To: Oshawa Active Transportation Advisory Committee
From: Projects Working Group 2023 08 21
Subject: Wentworth Street Reconstruction: Cedar Street to Farewell Street.

To provide comments regarding transportation on the proposed reconstruction of Wentworth Street by the Region.

Attachment 1

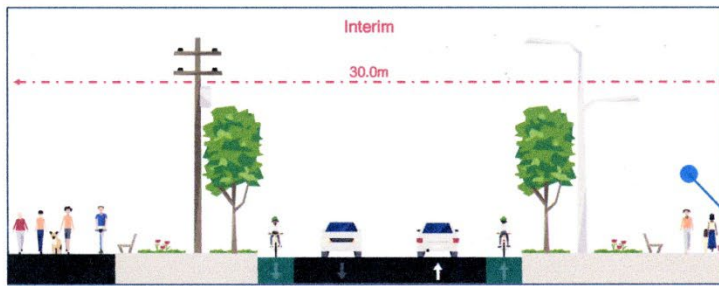
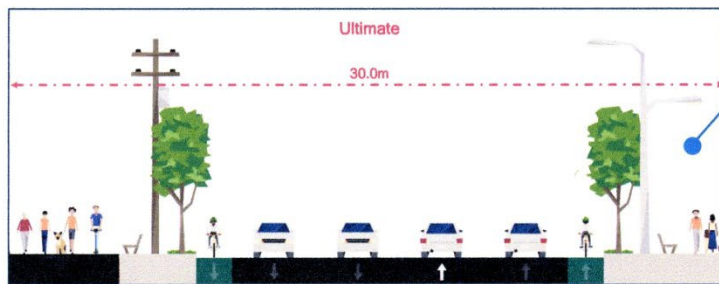
- 4.2 To provide a balanced road system cycle lanes or protected cycle lanes are required as well as the multi-use path on Type “C” arterial road with direct driveway access. A boulevard multi-use path provides beginners going to school or neighbours, for family outings with a safe facility as their speed does not insurmountably conflict with cars backing out of driveways waiting for a break in traffic and watching between the curb only. However experienced cyclists and e-scooters users going quickly to work or other functions would not be seen by drivers as they stop across the multiuse path to observe traffic between the curbs. For a balanced transportation system both facilities are required as shown on the City drawings for Stevenson Road N. Attachment No. 1 (From City of Oshawa Stevenson Road N. EA.)
